PRODUCT ADVISORY

Products: D2-DSCBL-2 Cables
Subject: Change to RS422 signal description
Number: PA-D2-014
Date Issued: 10/8/07
Revision: Rev B

Products Affected D2-DSCBL-2 Cables

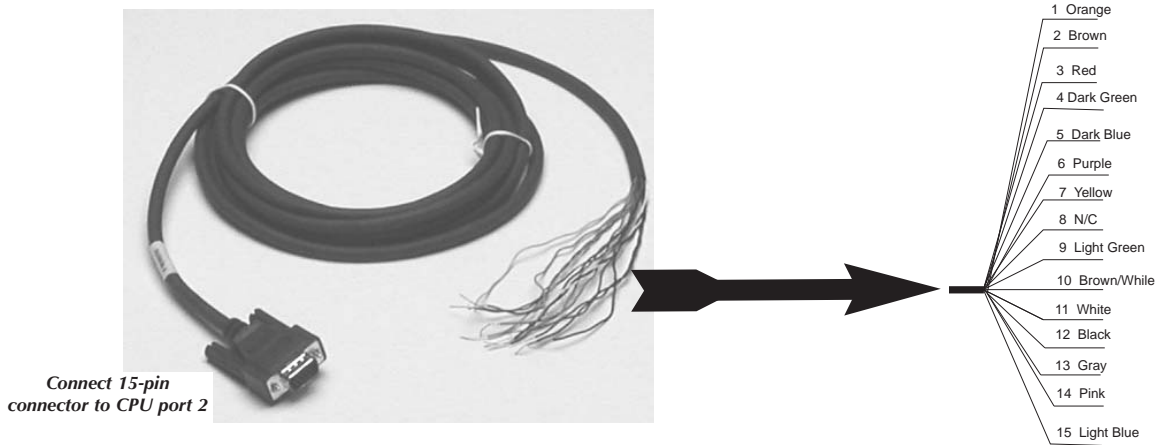
Description of Problem Wherever 'RS422' appears, it is to be replaced with 'RS422 / RS485'.

Pin Number	Signal	Pin-to-Wire Color (date codes prior to 2/02)	Pin-to-Wire Color (date codes 2/02 and later)
1	5 VDC	Black	Orange
2	TXD RS232	Brown	Brown
3	RXD RS232	Brown/White	Red
4	RTS RS232	Red	Dark Green
5	CTS RS232	Red/White	Dark Blue
6	- RXD RS422 / RS485	Orange	Purple
7	0V Logic Ground	Black/White	Yellow
8	0V Logic Ground	N/C	N/C
9	+ TXD RS422 / RS485	Yellow	Light Green
10	- TXD RS422 / RS485	Yellow/White	Brown/White
11	+ RTS RS422 / RS485	Green	White
12	- RTS RS422 / RS485	Green/White	Black
13	+ RXD RS422 / RS485	Orange/White	Gray
14	+ CTS RS422 / RS485	Blue	Pink
15	- CTS RS422 / RS485	Blue/White	Light Blue
